CITY OF RAPID CITY

Growth Management Department

Re: Request for Exception to the requirement to install a reinforced concrete driveway.
Lot 1 of Block 2 Northstar Subdivision, NE ¼ of NE ¼ of S29, T2N, R8E, B.H.M.

REINFORCED DRIVEWAY AND SIDEWALK (PROPERTY LINE SIDEWALK SHOWN)

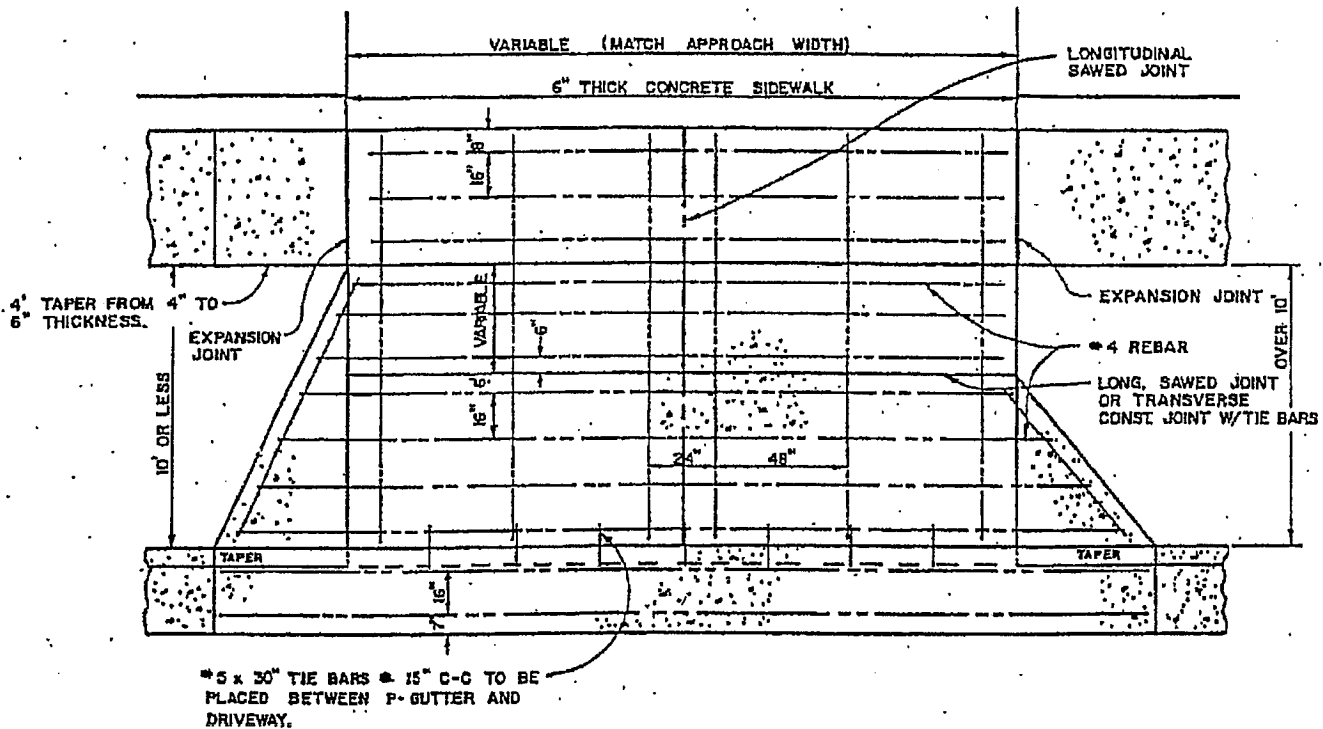
The Request for Exception to Section 8.2.1, of the City of Rapid City Street Design Criteria Manual, to construct an asphalt or asphalt millings driveway in lieu of the required reinforced concrete driveway into the proposed improvements on the referenced property is denied.

The Rapid City Street Design Criteria Manual, Section 8.2.1, Paragraph B, states "... Reinforced driveway and sidewalk shall be placed at all alley entrances and at driveways into property which is zoned Commercial, Light Industrial and Heavy Industrial, See Figure 8-4." A copy of Section 8.2.1, Paragraph B and Figure 8-4 are attached for reference. The proposed asphalt or asphalt millings driveway as indicated on the project drawings does not comply with the requirements for a reinforced driveway as specified in the Street Design Criteria Manual.

Reinforced concrete driveways are typically required at entrances to commercial and industrial facilities due to the sharp turns and frequent stopping and starting of heavy trucks and equipment entering and leaving these facilities. Asphalt or asphalt millings may rut and deteriorate which may damage the street surfacing and allow tracking of dirt and debris on to the street. Currently there are no major improvements projects in this area listed in the City's One or Five Year Capital Improvements Plans.

REINFORCED DRIVEWAY & SIDEWALK shall be placed at all alley entrances & at driveways into property which is zoned Commercial, Light Industrial, and Heavy Industrial. No. 4 rebar shall be placed as per detail and tied together. Two inch (2") clearance shall be maintained between bottom of concrete & rebar.
